ADDENDUM NO. TWO (2)
TOWN OF BRASELTON, GEORGIA
2026 GROUNDWATER EXPANSION AND DISTRIBUTION STORAGE
ISSUED JANUARY 23, 2026

RE: 2026 GROUNDWATER EXPANSION AND DISTRIBUTION STORAGE
EMI PROJECT No. 18-021

The purpose of this Addendum is to provide the omitted storage tank drawings, existing contours for treatment site, the pre-bid meeting attendance, and add Precon Corporation as a pre-approved concrete storage tank manufacturer. The following items of the Contract Documents are modified as part of this Addendum:

TYPICAL PIPE ENCASEMENT AT FOOTING

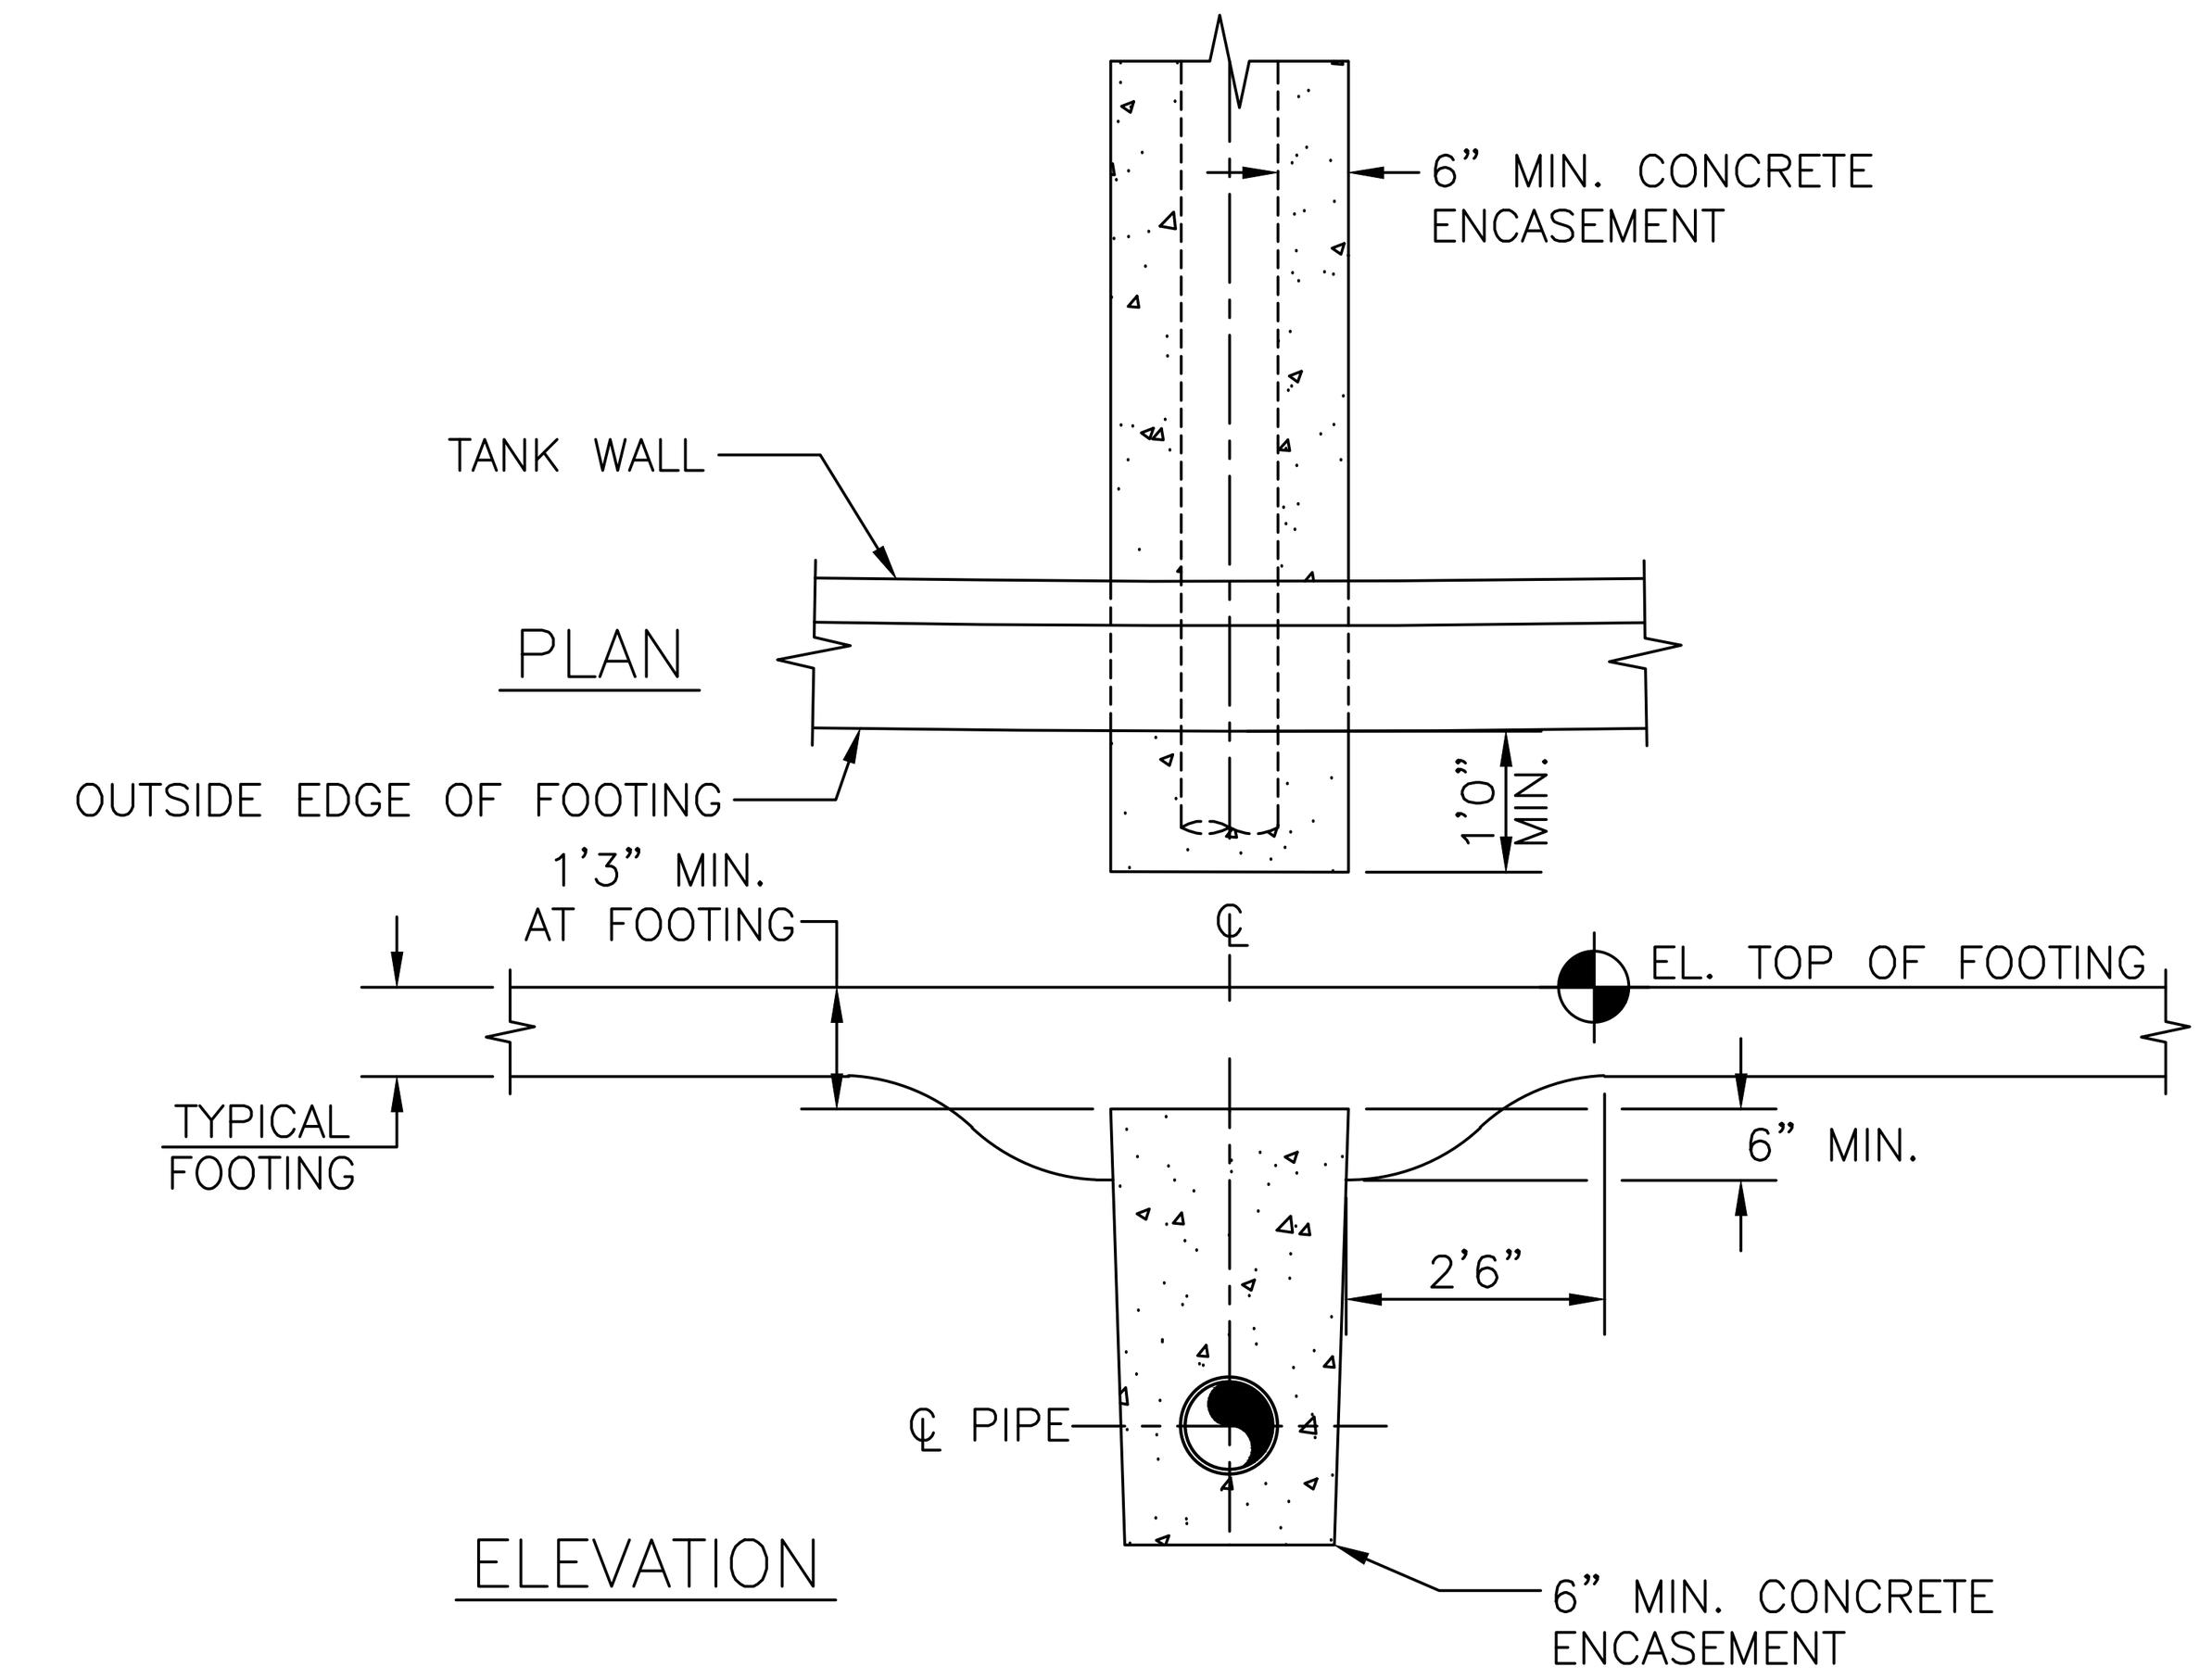
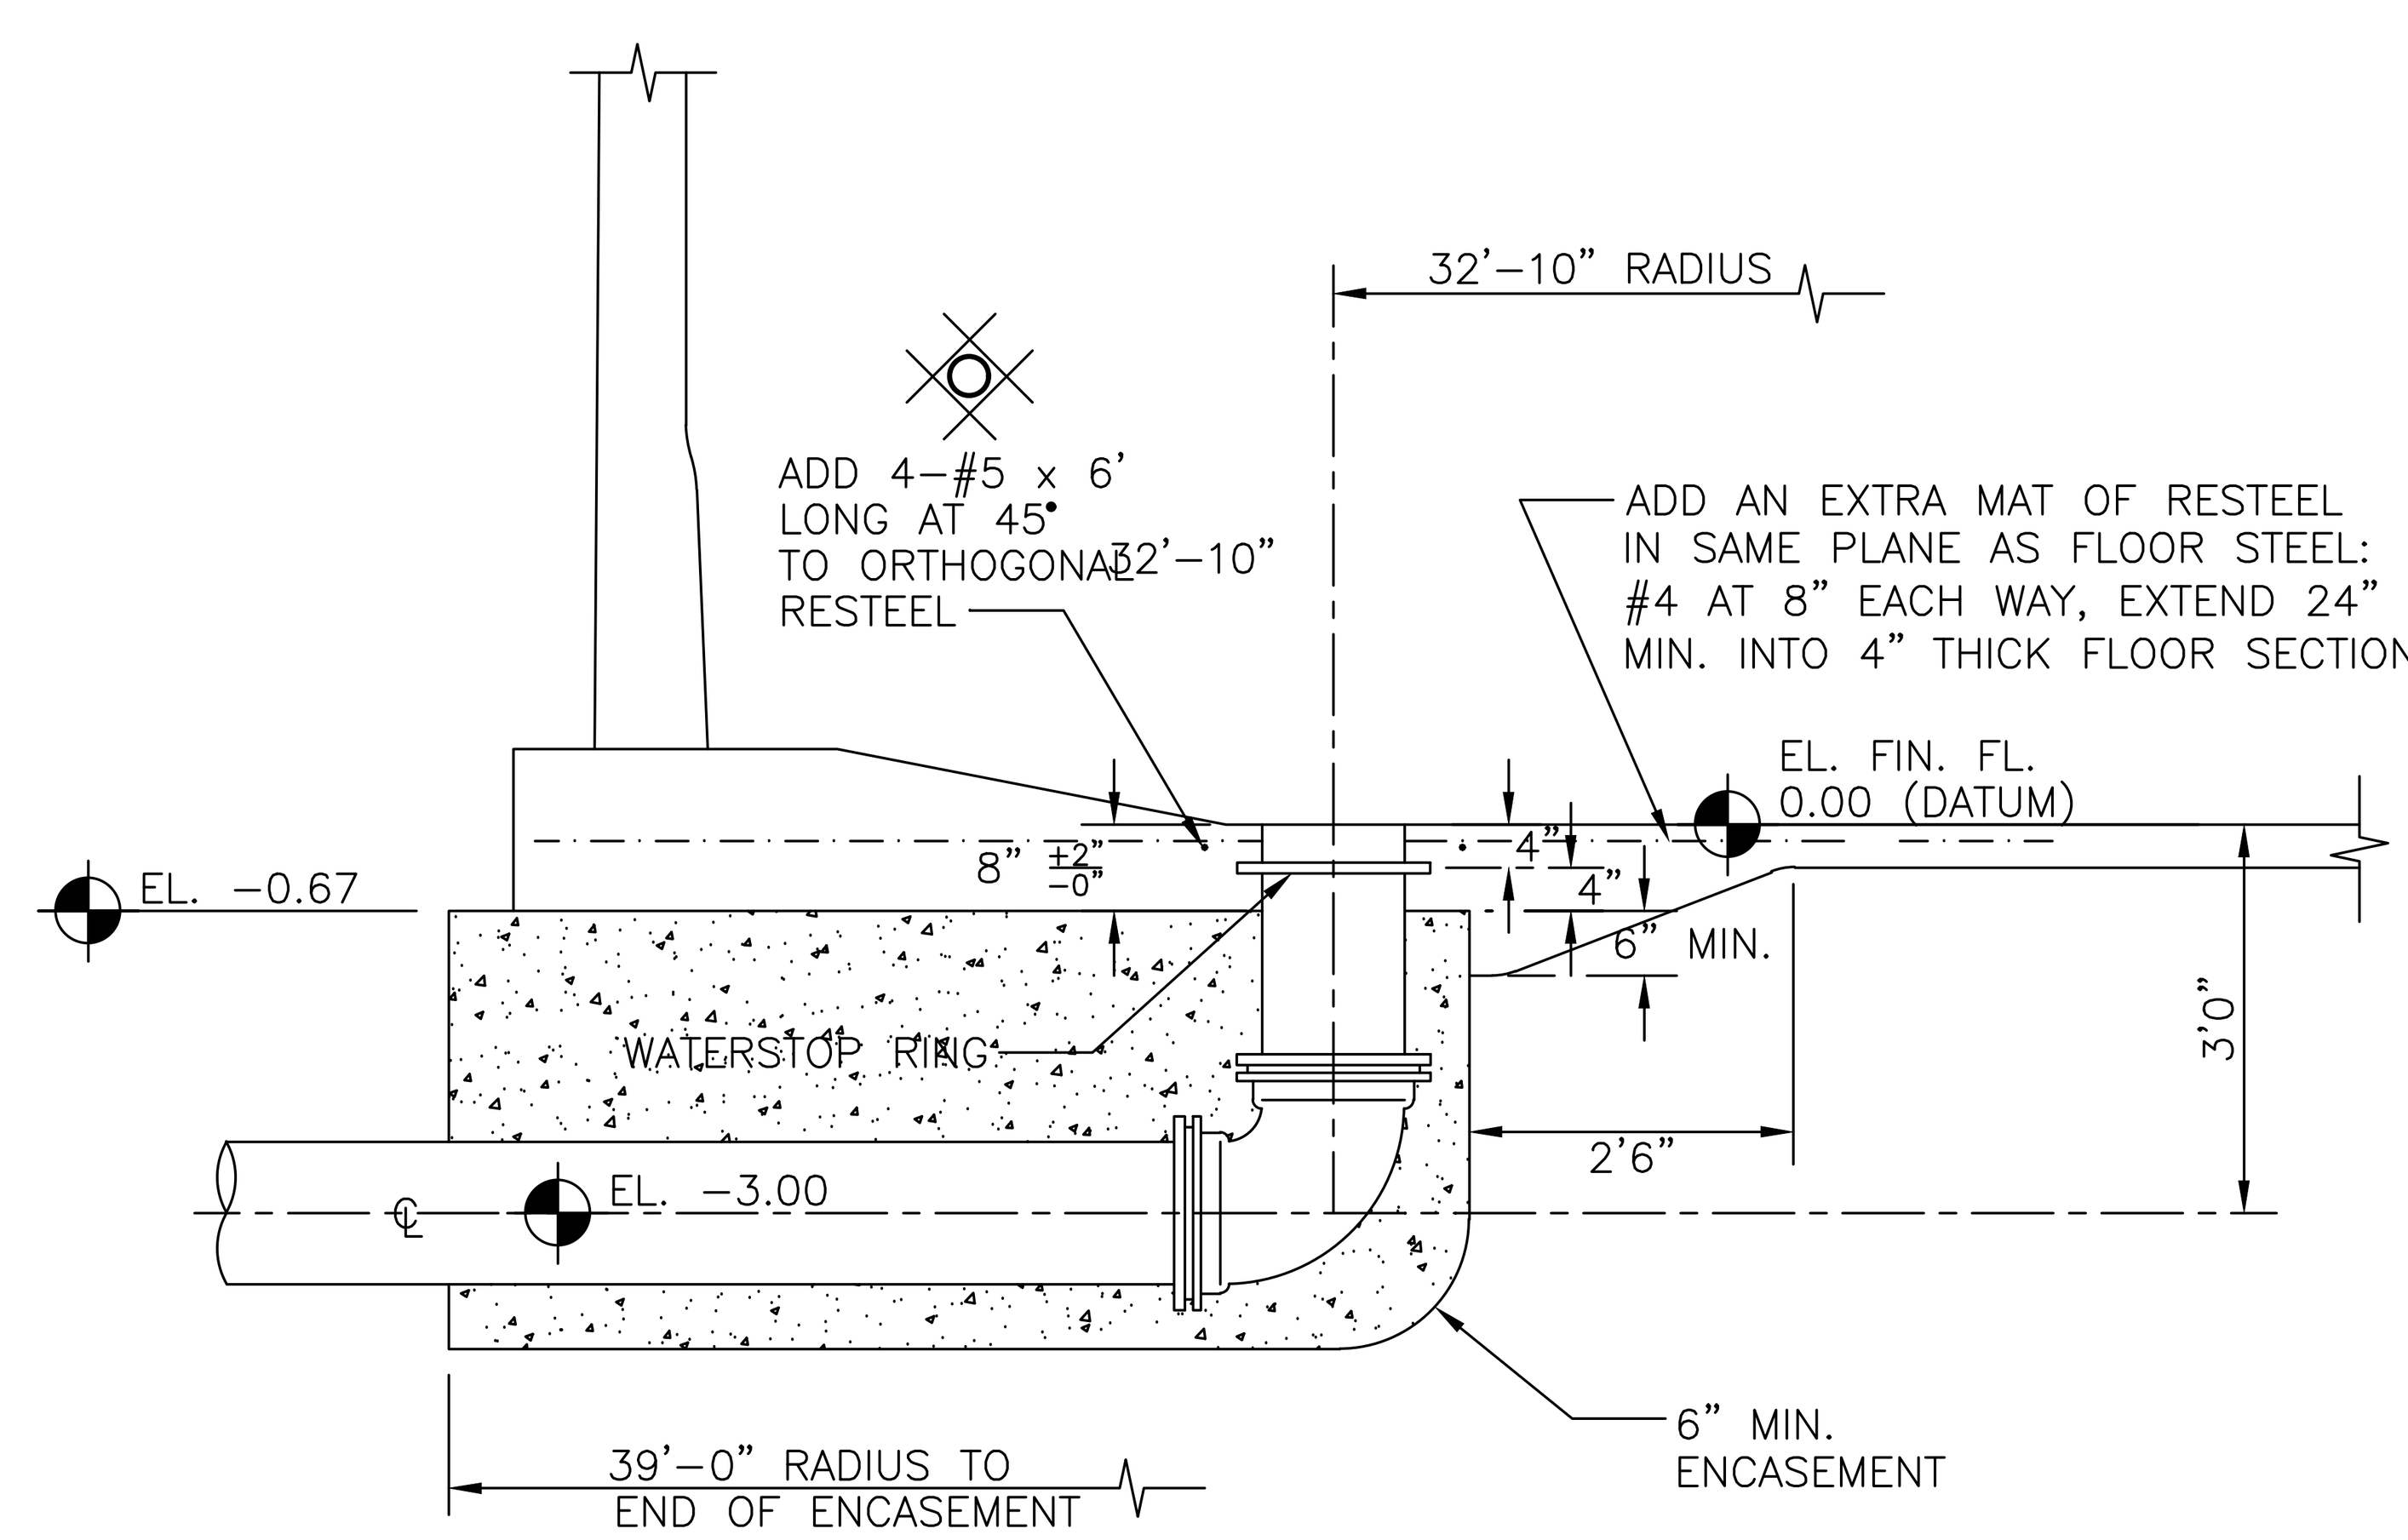
1. The contract documents appear to be missing plan sheets M7-M10 for the new tank listed in the sheet index. Can you please provide the missing drawings?

- <u>*Plan sheets M7-M10 have been provided to show plans for the concrete storage tank. See attached plan sheets.*</u>

EMI Response: Sheets M7-M10 were omitted in error. Please see the original sheets attached to this addendum.
